E8362C-01A

S E R V I C E N O T E

E8362C PNA Microwave Network Analyzers

A new touchscreen display inverter shield is available to improve PNA noise floor performance.

Figure 3

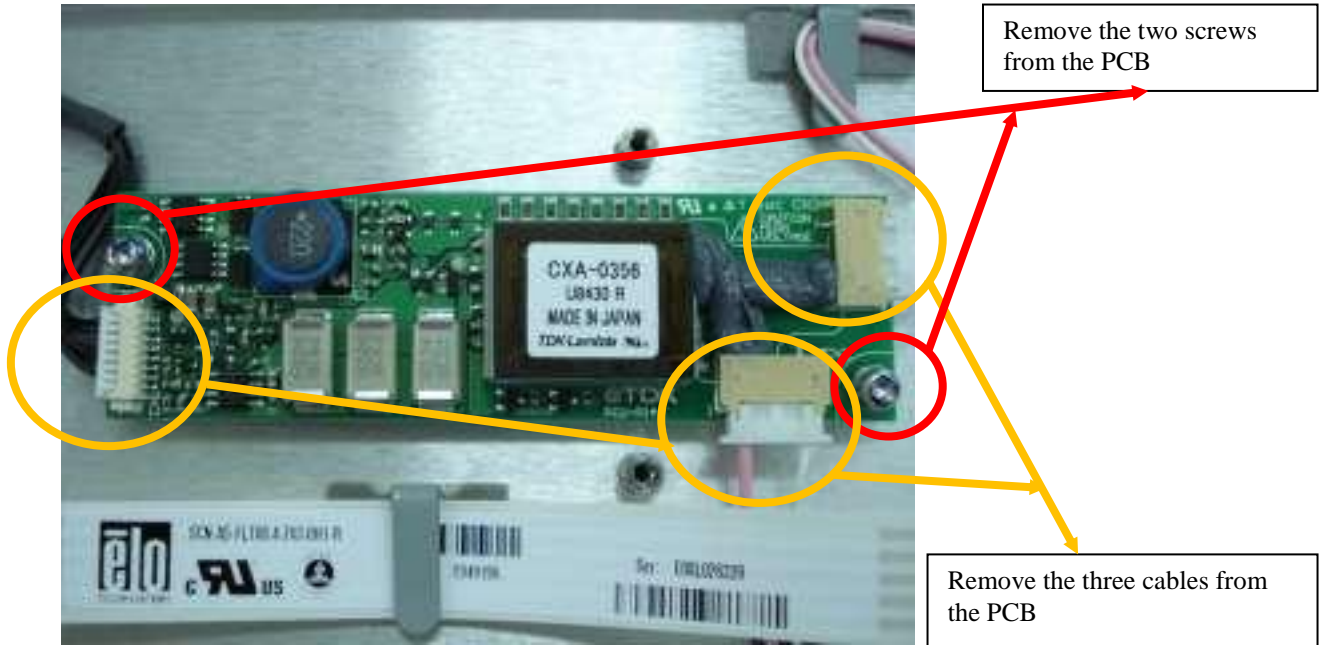
10. Remove the two screws from the PCB shown in Figure 3, using a T-10 wrench. Disconnect the three cables connected to the PCB.
